KWM-380 TRANSCEIVER (622-5093-101)
HF-380 TRANSCEIVER (622-3580-101)
RECEIVER-EXCITER CIRCUIT CARD A3 (638-6908-001)

SERVICE BULLETIN NO 1**PRODUCT IMPROVEMENT**

This is a nonmandatory service bulletin which applies to the following:

P/O Receiver/Exciter Circuit Card A3
Figure 1

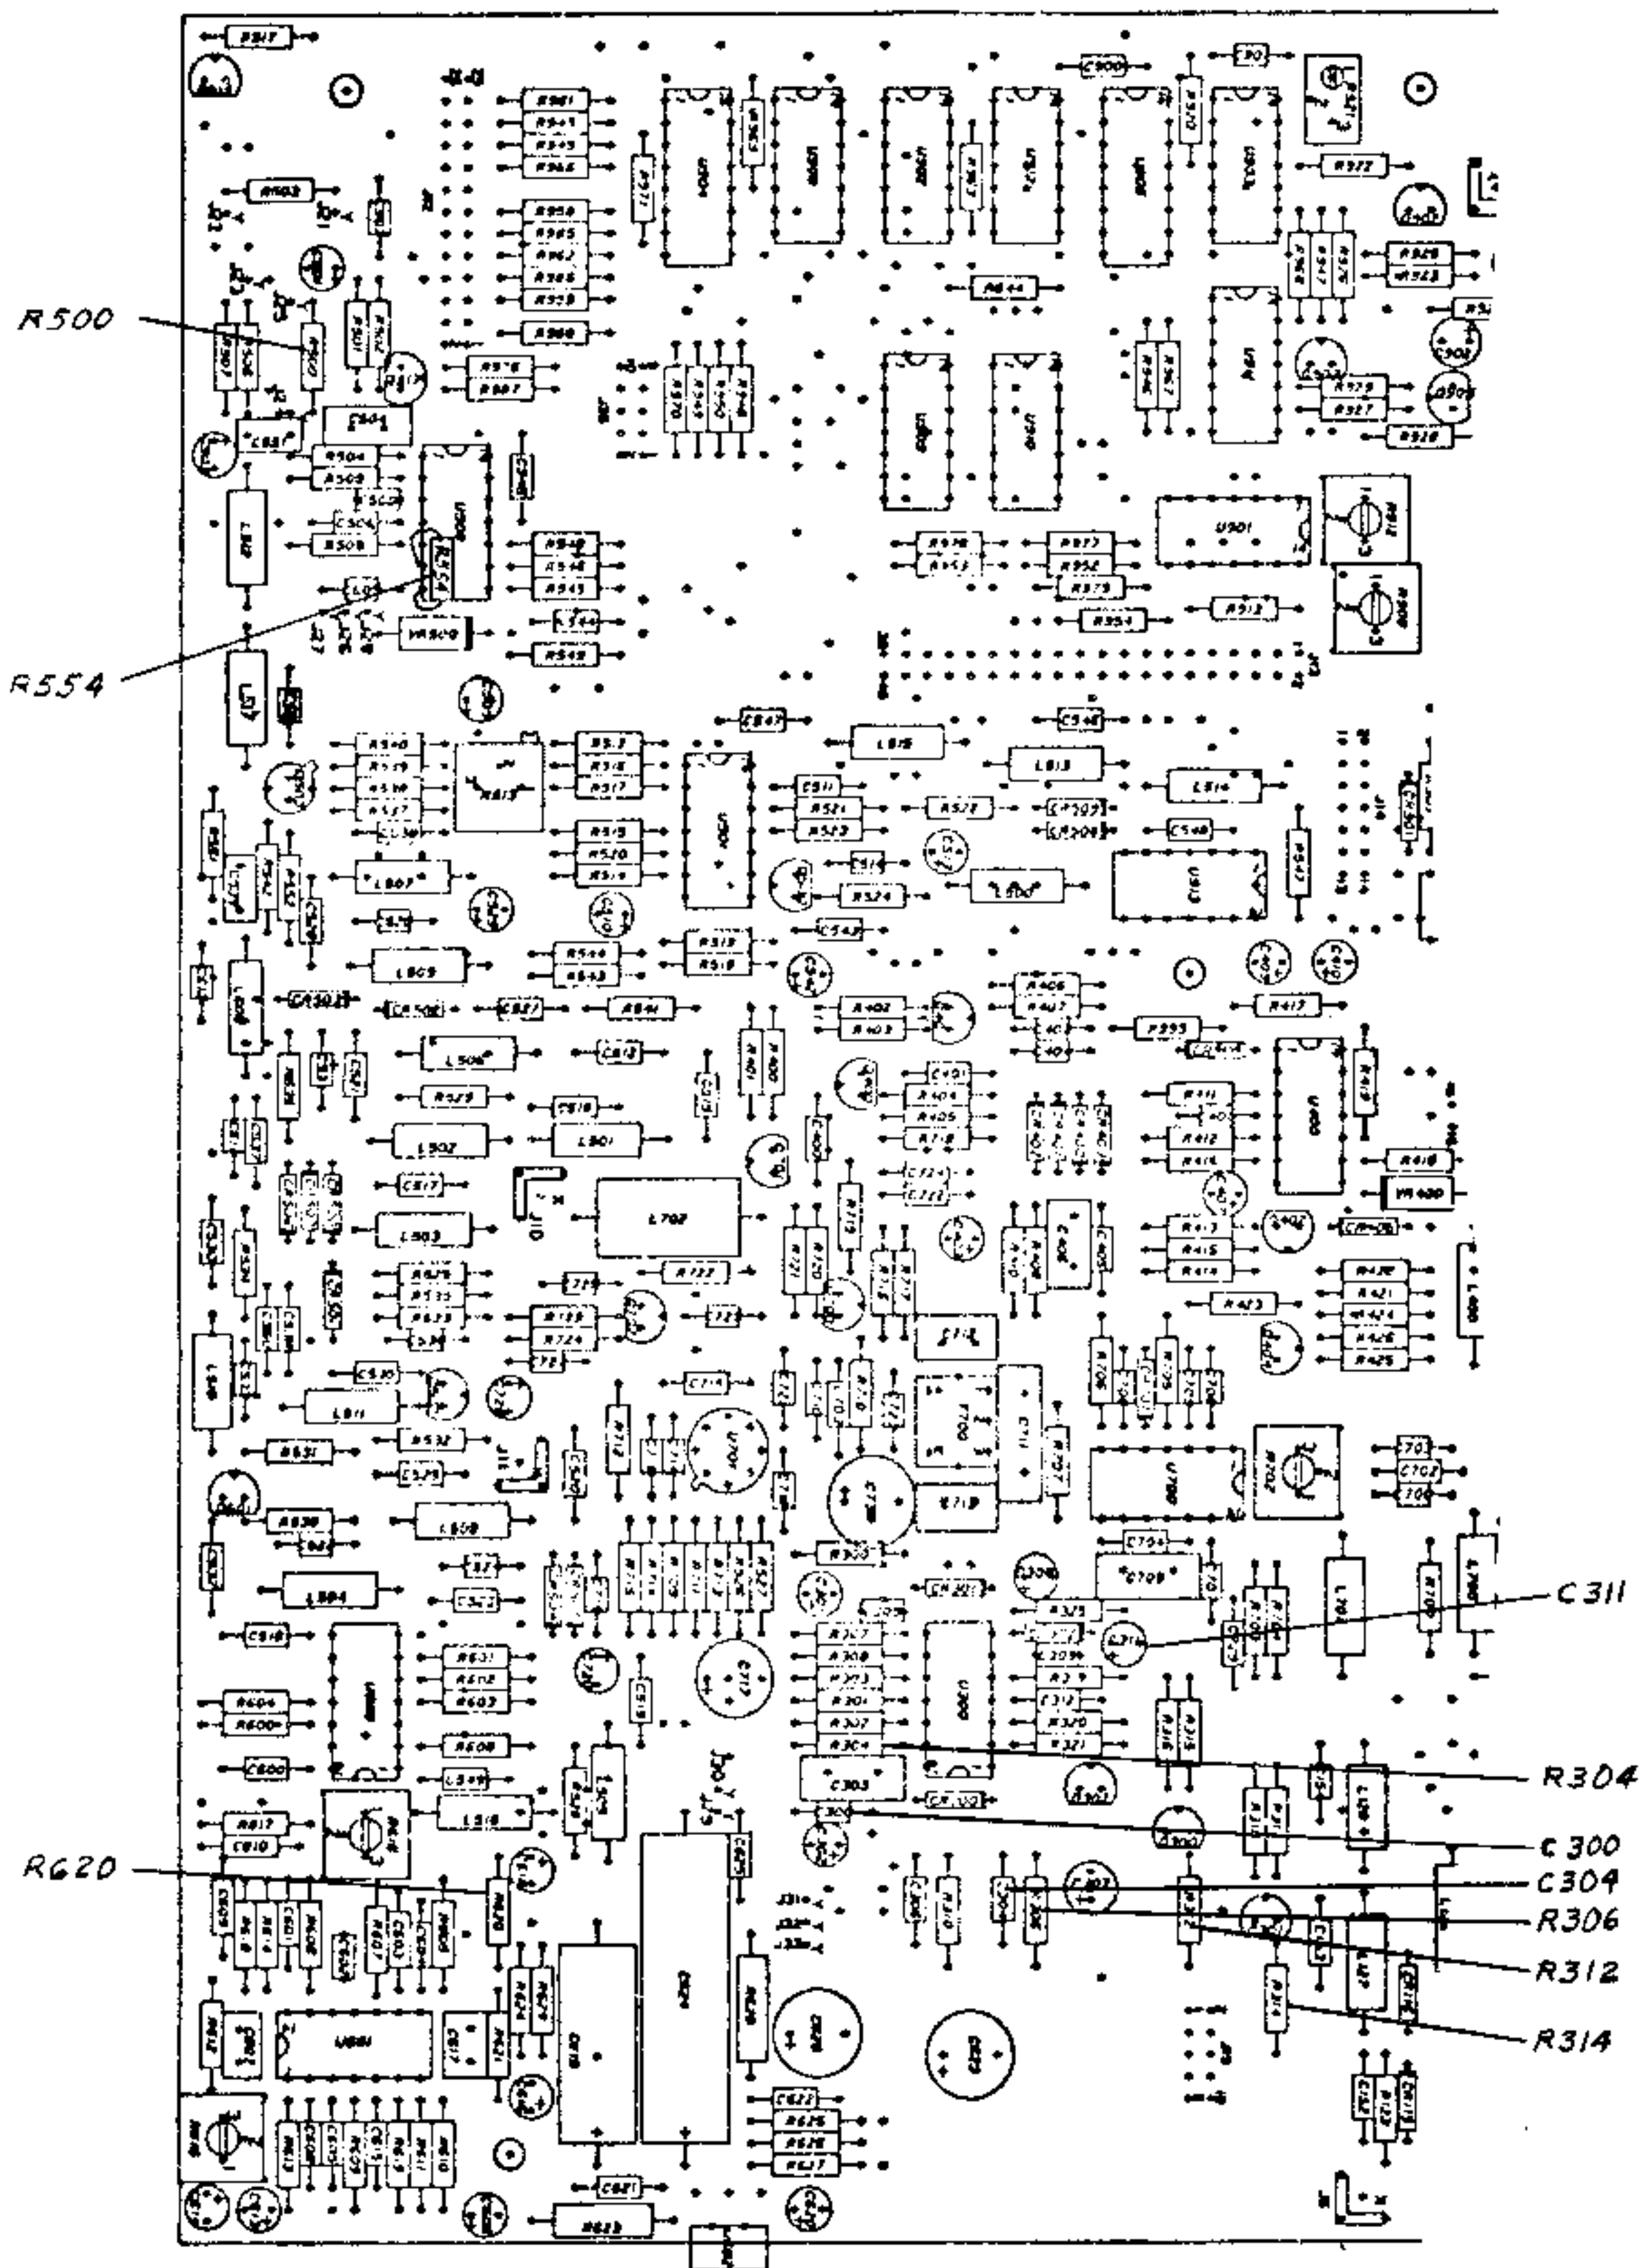
- C. Remove 100-k Ω resistor R554 and replace it with a 1-M Ω resistor (745-2449-000).
- D. Remove 270- Ω resistor R500 and replace it with a 3.3-k Ω resistor (745-0767-000).

- E. Remove 33-k Ω resistor R620 and replace it with an 18-k Ω resistor (745-0794-000).
- F. Remove 1- μ F capacitor C311 and replace it with a 0.22- μ F capacitor (184-9102-310).

- G. Remove 1-M Ω resistor R304 and replace it with a 100-k Ω resistor (745-0821-000).
- H. Remove 0.01- μ F capacitor C300 and replace it with a 1000-pF capacitor (913-3281-270).

- I. Remove 0.1- μ F capacitor C304 and replace it with a 4.7- μ F capacitor (184-9102-390). The negative lead of the capacitor should be connected to the hole on the left.

- J. Remove 1-k Ω resistor R306 and replace it with a 100- Ω resistor (745-0713-000).
- K. Remove 47-k Ω resistors R312 and R314 and replace them with 10-k Ω resistors (745-0785-000).

P/O Synthesizer Card A5A1 (638-6916-002)
Figure 2

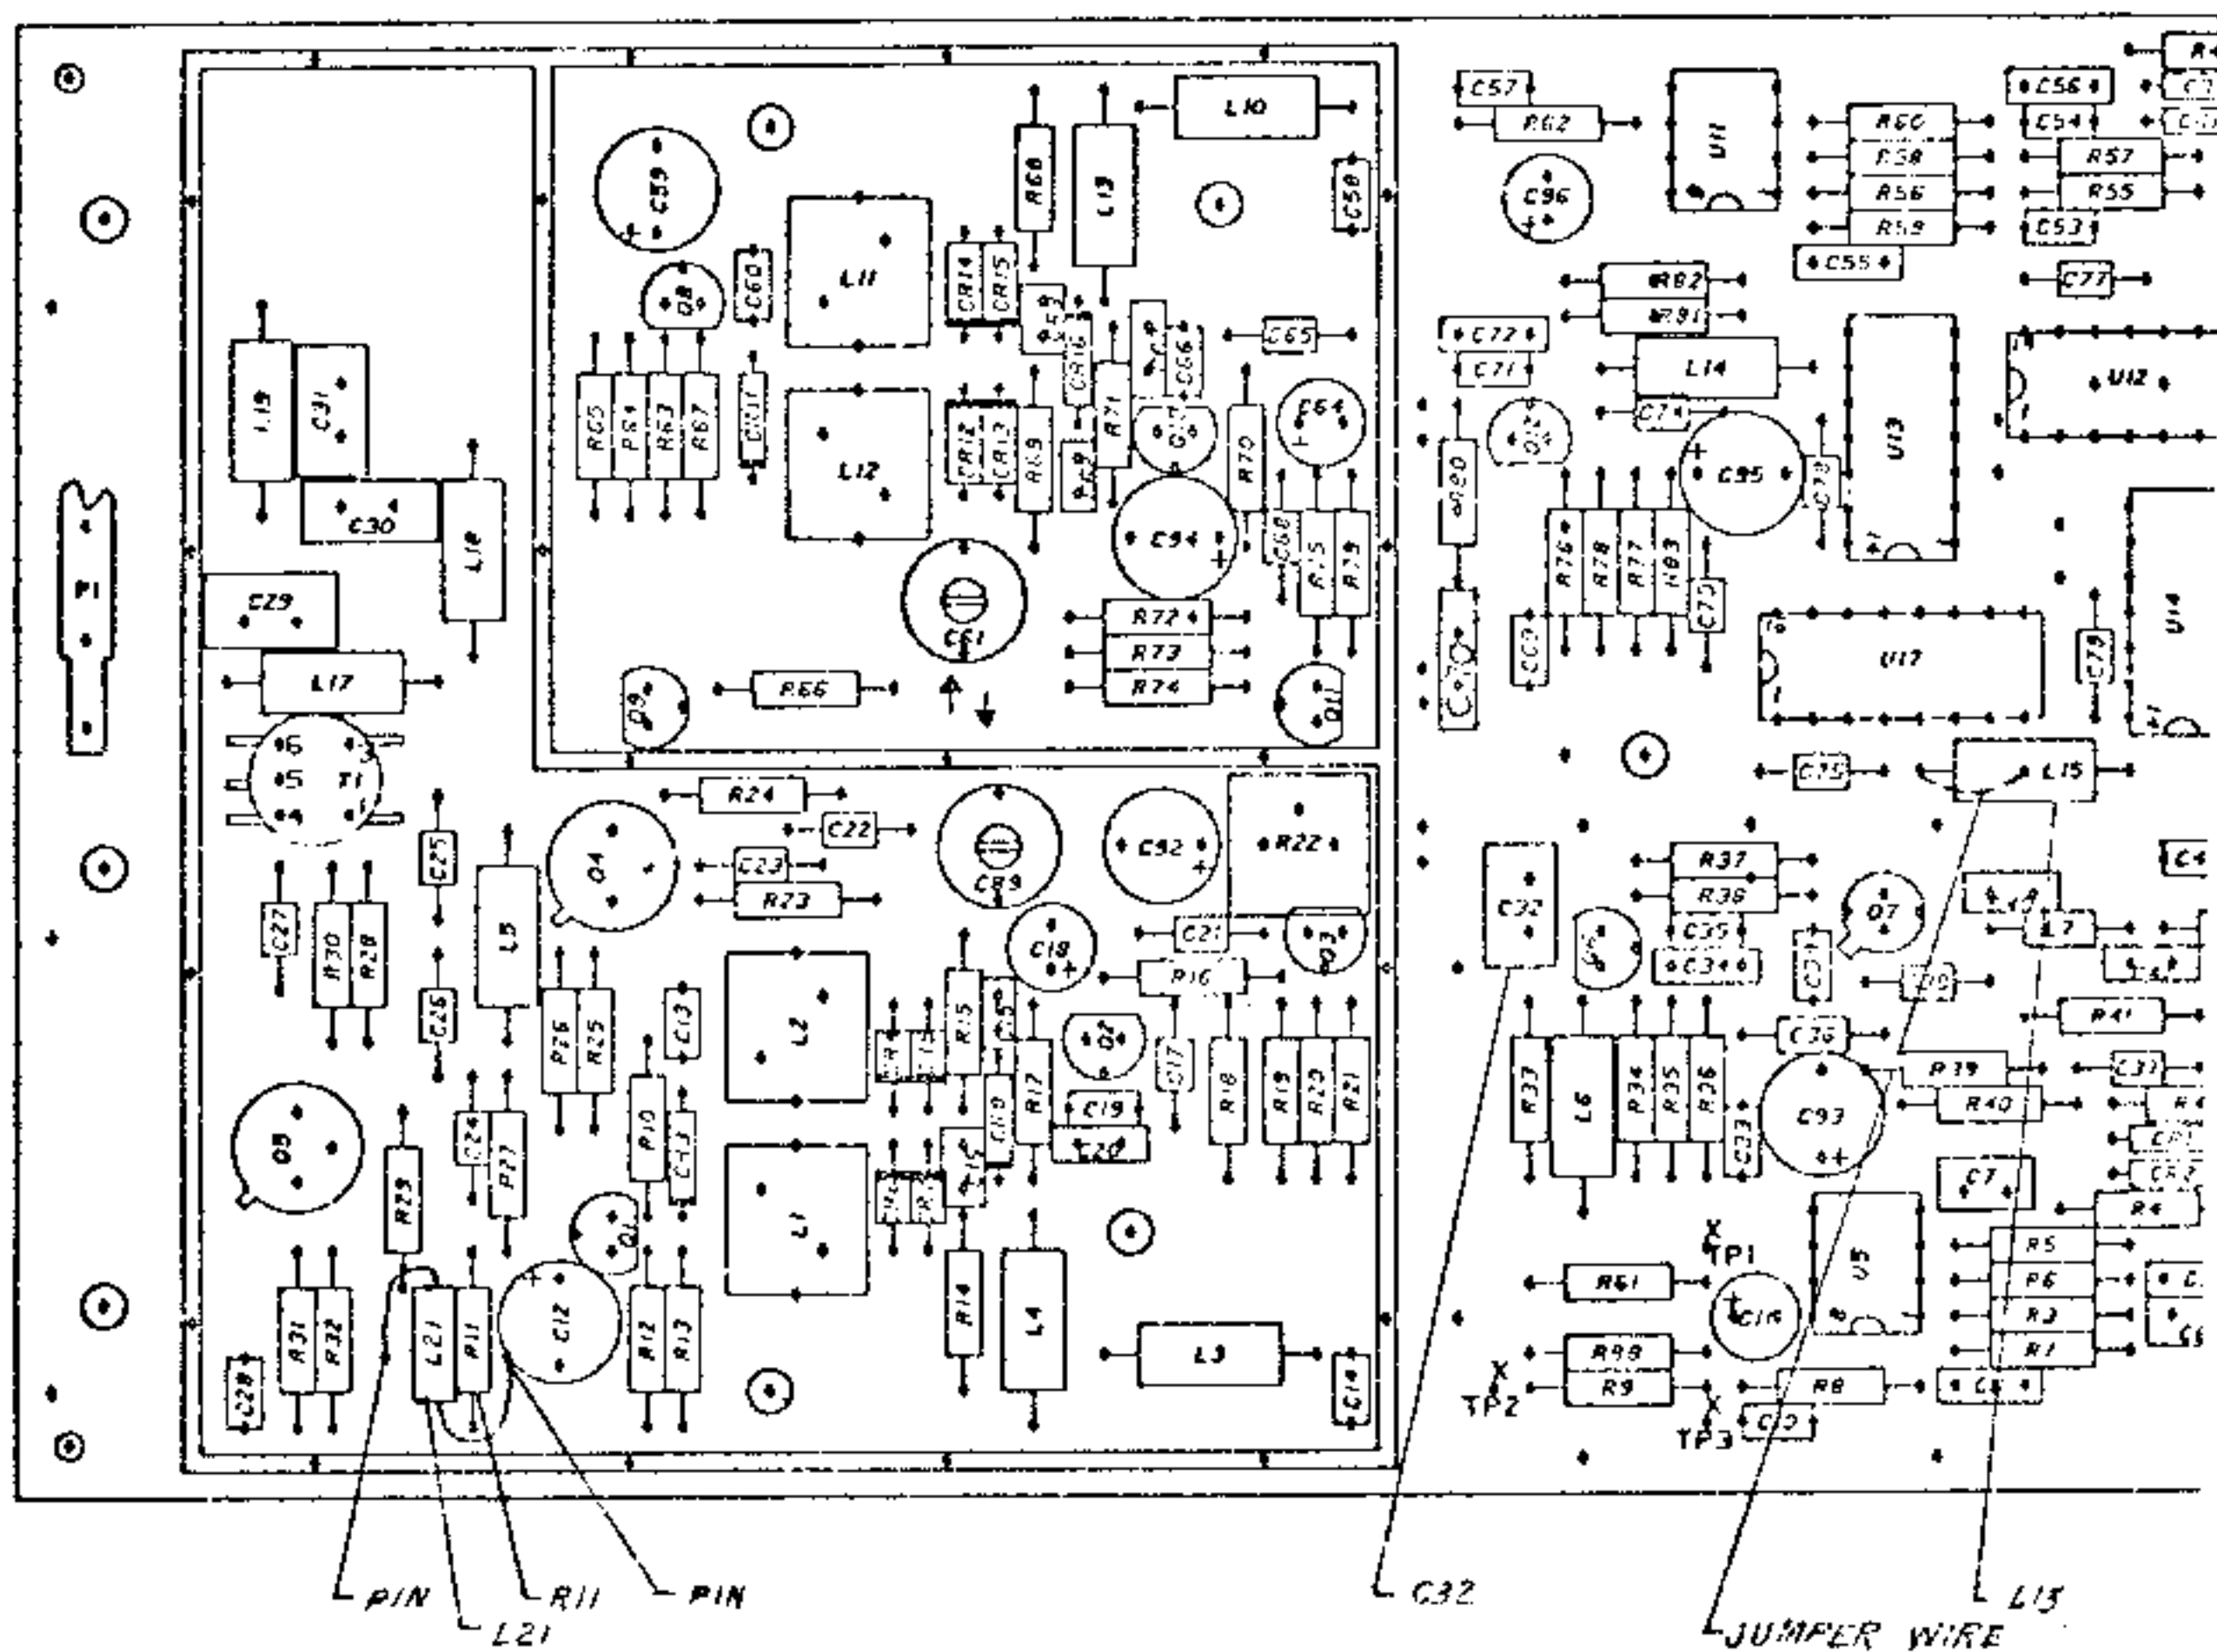
- E. Remove A5A1 from A5 assembly by removing seven screws.
 - F. On the top of A5A1, cut circuit trace at right lead of coil L15.
 - G. On top of card, cut circuit trace located between thru holes where two new pins are shown in figures 1 and 2.

- J. Remove the 27-pF capacitor C32 and replace it with an 18-pF capacitor (913-1098-030).
 - K. On the bottom of the card, install a jumper wire (428-0282-050) from the left lead of L15 to the thru hole located under L15.
